**NORTH SALT LAKE PLANNING COMMISSION  
NOTICE & AGENDA  
May 24, 2022  
6:30 p.m.**

**TO:** Planning Commission  
**FROM:** Mackenzie Bennett, Planner  
**DATE:** May 24, 2022  
**SUBJECT:** Site Plan Amendment for the Collective Campus, 1375 West Center Street

# COLLECTIVE CAMPUS BUILDING RENOVATION

SITE PLAN APPLICATION - REVISED

**EXTERIOR  
ELEVATIONS -  
PROPOSED**  
**A201**

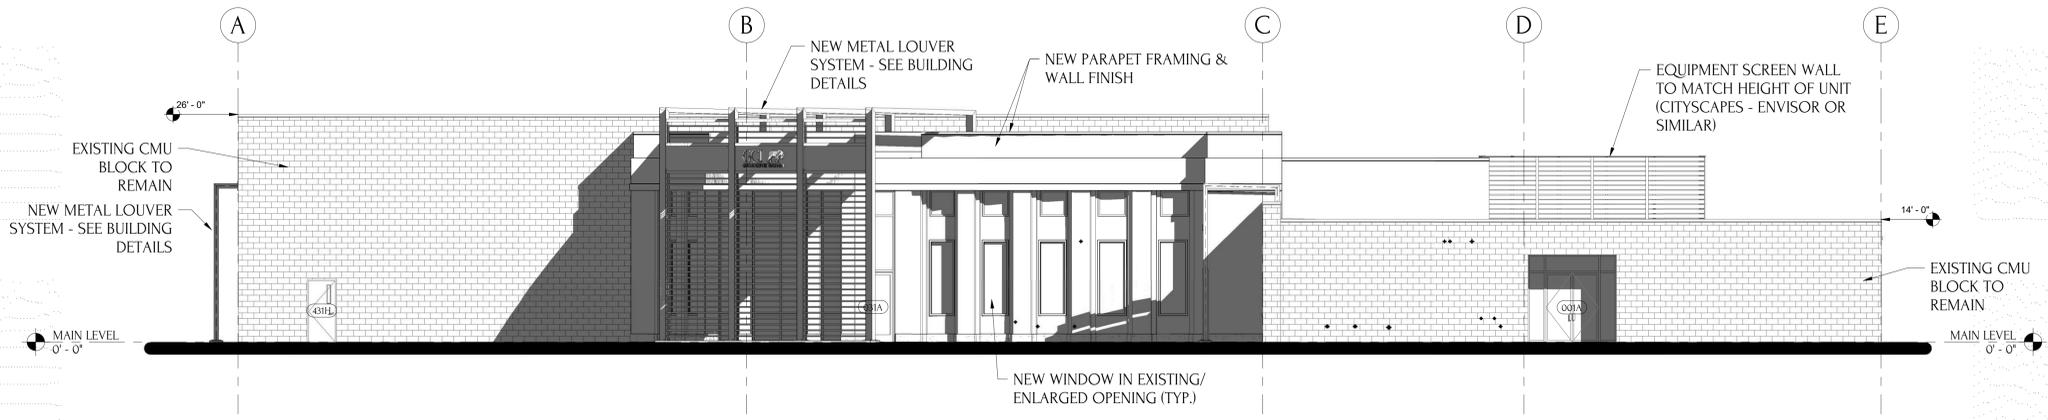
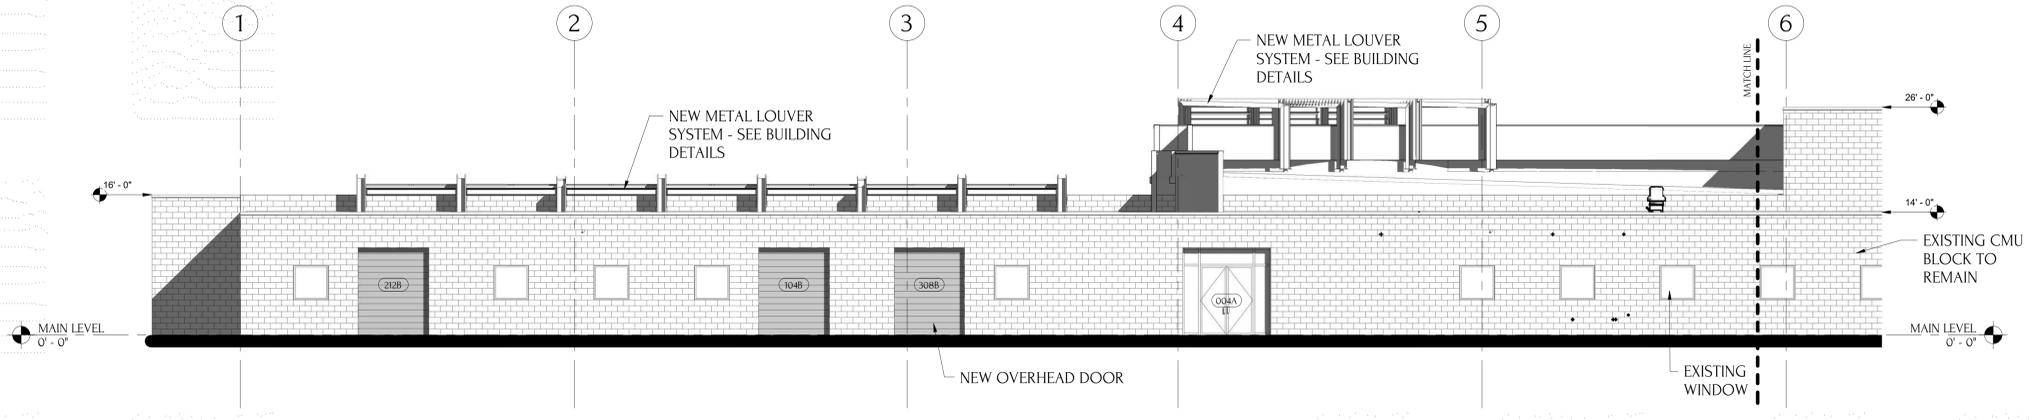
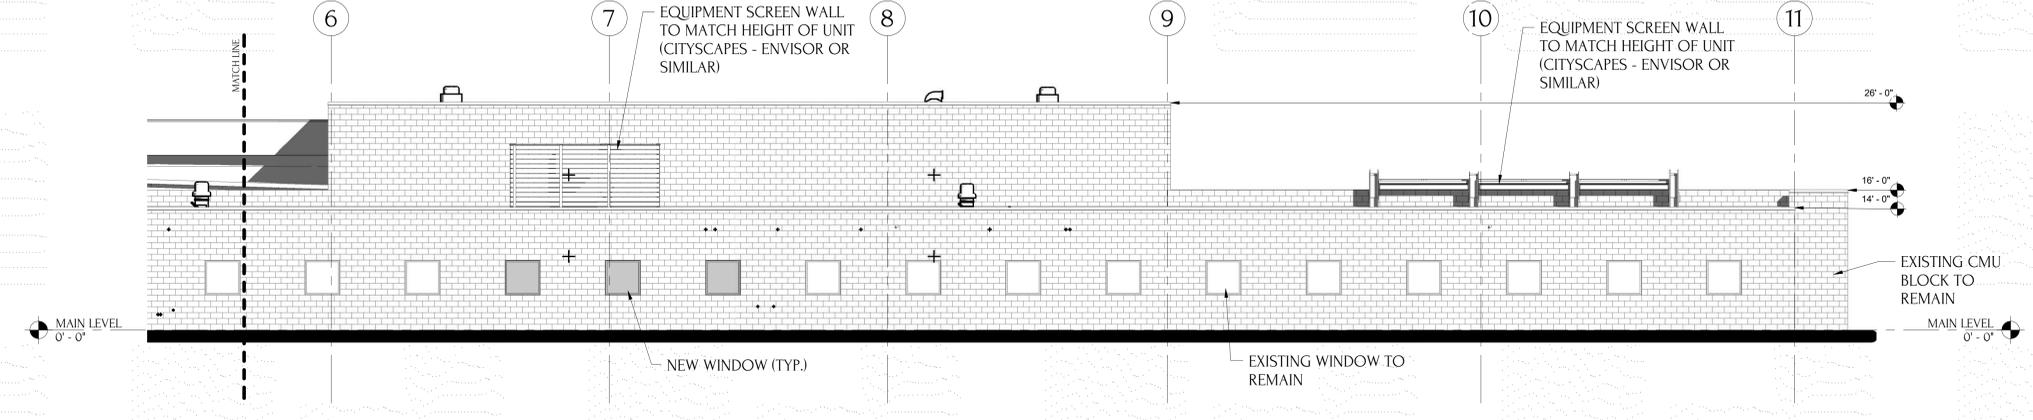
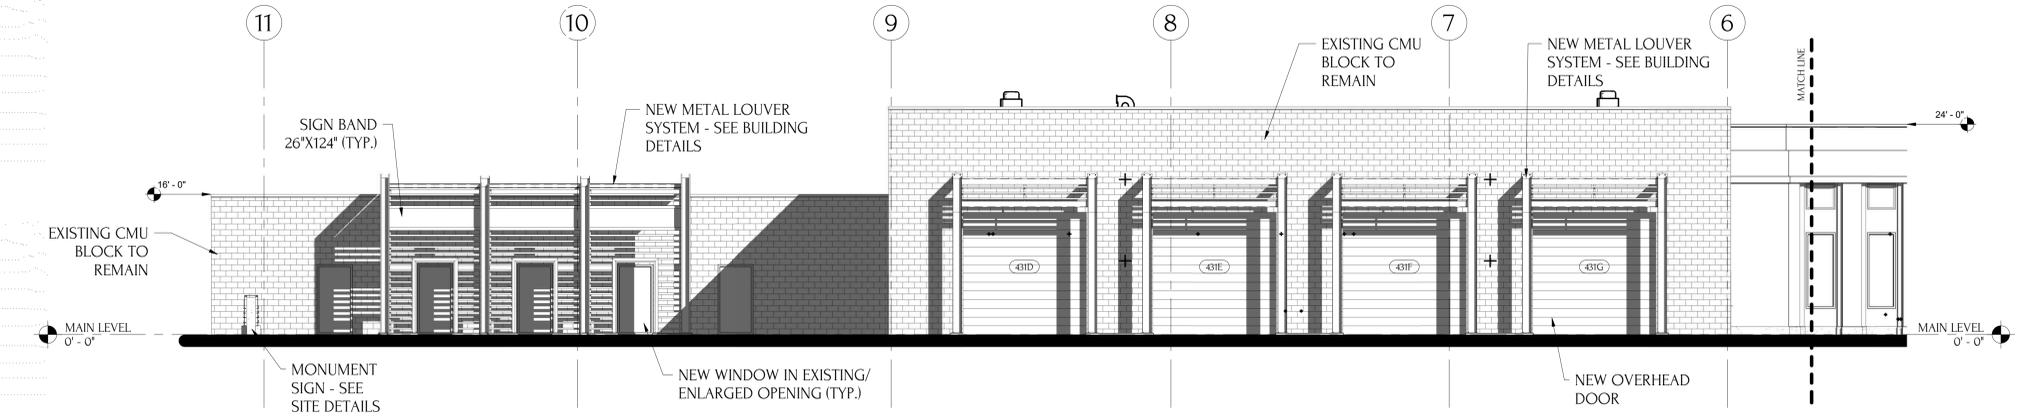
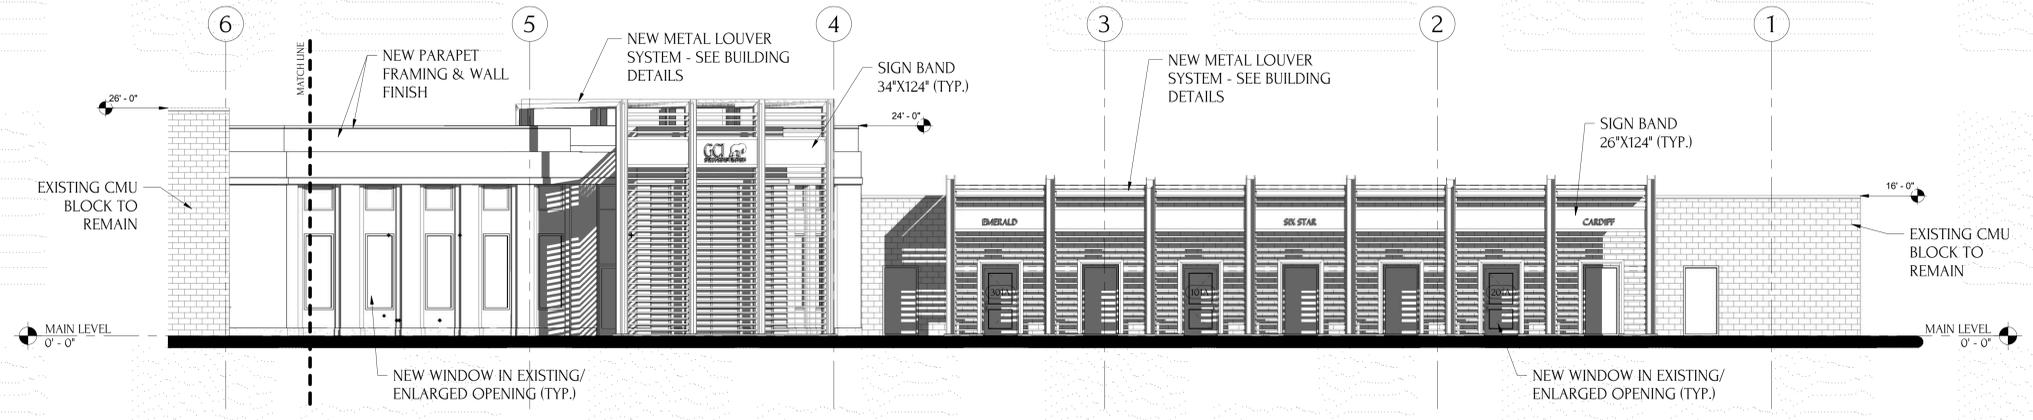
- Horizontal Articulation every 100 feet-*Each facade greater than one hundred feet (100') in length, measured horizontally, shall incorporate architectural features such as wall plane projections, recesses, or other building material treatments, colors and textures that visually interrupt the wall plane. No uninterrupted length of a facade may exceed one hundred (100) horizontal feet. (meets standard)*

- Vertical Articulation every 30 feet in height-*max height 45 feet (meets standard)*
- Parapet Variation every 60 linear feet-*All facades visible from a public right of way shall include a parapet that varies in height by at least two feet (2') for each sixty (60) linear feet of facade length. (meets standard)*

- *Primary Building Entrance: Any primary entrance shall be clearly defined by either recessing the entrance or with a sheltering element such as an awning, arcade, or portico to provide shelter from the sun and inclement weather. (meets standard)*

- High quality materials-factory finished, integrally colored, or otherwise suitably treated **(meets standard)**
- Metal siding, or materials which appear to be metal siding, prohibited except as accents (20%) **(meets standard)**
- Metal roofs & doors permitted **(meets standard)**
